Work Order ID 97868

Item Name: Crosstube Turning Detail

| DE APPR. | RF | CROSSTUBE ASS'Y (407 HIGH AFT) | NTS |

| DRAWING NO. D407-667-245 | TITLE CROSSTUBE ASSY (407 HIGH AFT) | REV. F | DART AEROSPACE LTD ENGINEERING ORDER | | D.E.O. NO. D407-667-245-F-1 | SHEET NO. SHEET 1 OF 2 | SCALE NTS |

| DRAWING NO. D407-667-245 | TITLE CROSSTUBE ASSY (407 HIGH AFT) | REV. F | DART AEROSPACE LTD ENGINEERING ORDER | D.E.O. NO. D407-667-245-F-1 | SHEET NO. SHEET 2 OF 2 | SCALE NTS |

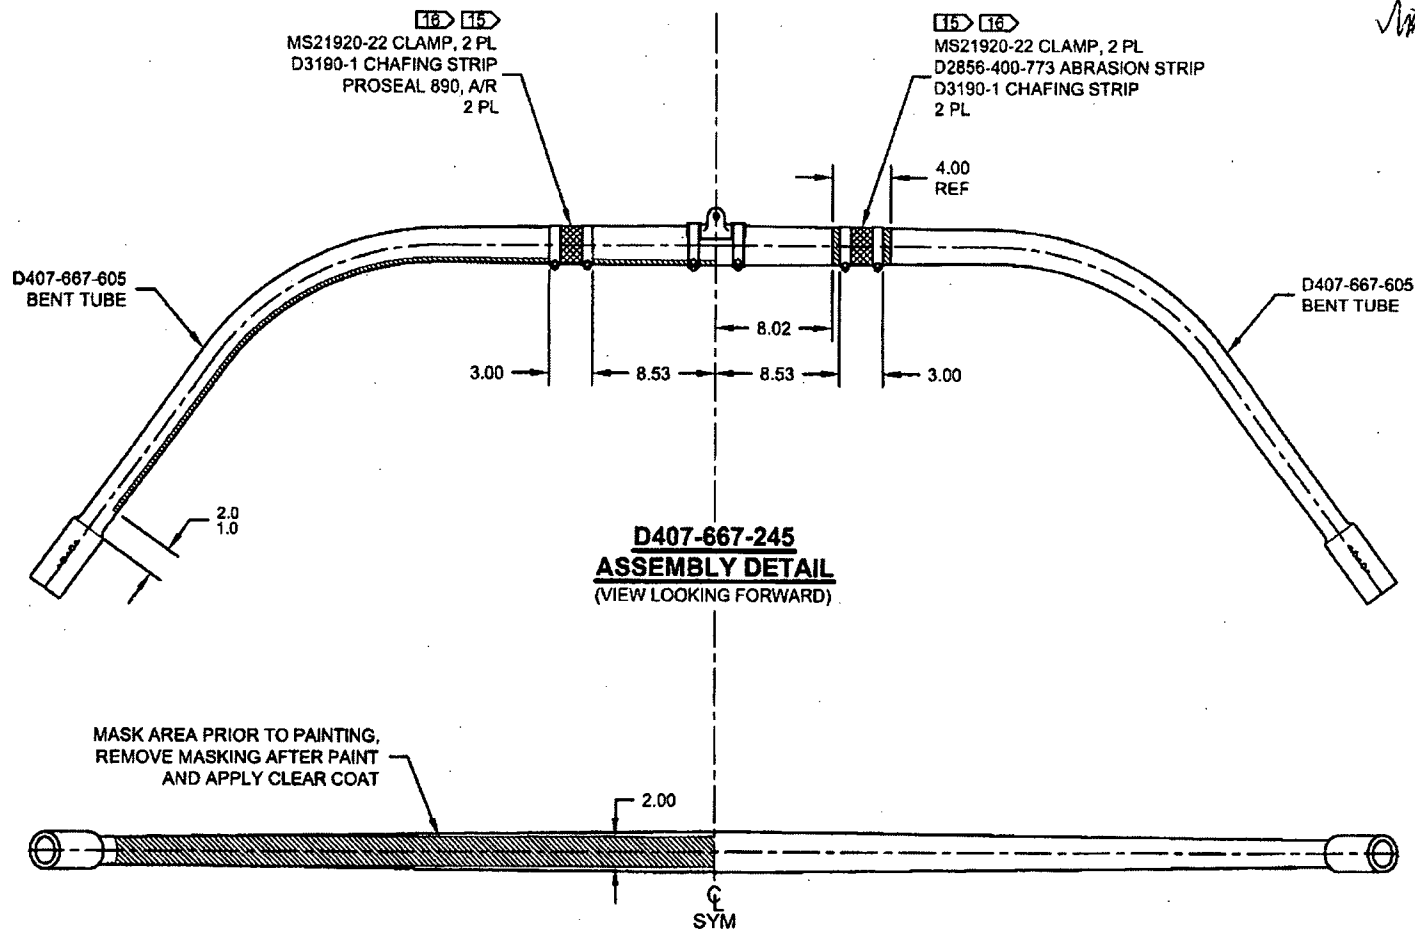
PURPOSE:

REMOVED ABRASION STRIP IN FAVOR OF A THIN LAYER OF PROSEAL 890.

NOTES 2 AND 15, SHEET 1 ARE AMENDED AS FOLLOWS:

- 2) FINISH: CHEMICAL CONVERSION COAT PER DART QSI 005 4.1
PRIME INSIDE AND OUTSIDE PER DART QSI 005 4.2
MASK UNDERSIDE OF CROSSTUBE AS SHOWN (HATCHED AREA) AND
PAINT OUTSIDE PER DART QSI 005 4.2
REMOVE MASKING AND APPLY CLEAR COAT
- 15) APPLY A THIN COAT OF PROSEAL 890 ON INSIDE CONCAVE SURFACE OF D3190-1
CHAFING SHIELDS AND LET CURE PER MANUFACTURER'S INSTRUCTIONS. INSTALL
PROSEALED D3190-1 CHAFING SHIELDS ONTO CROSSTUBE BY APPLYING A THIN COAT
OF PROSEAL 890 ONTO CROSSTUBE. BE SURE TO ELIMINATE ANY AIR GAPS.

- 2) FINISH: CHEMICAL CONVERSION COAT PER DART QSI 005 4.1
PRIME INSIDE AND OUTSIDE PER DART QSI 005 4.2
PAINT OUTSIDE PER DART QSI 005 4.2
- 15) INSTALL D2856-400-773 ABRASION STRIP WITH A 0.13 REF GAP ON BOTTOM SIDE OF
CROSSTUBE PER QSI 035.
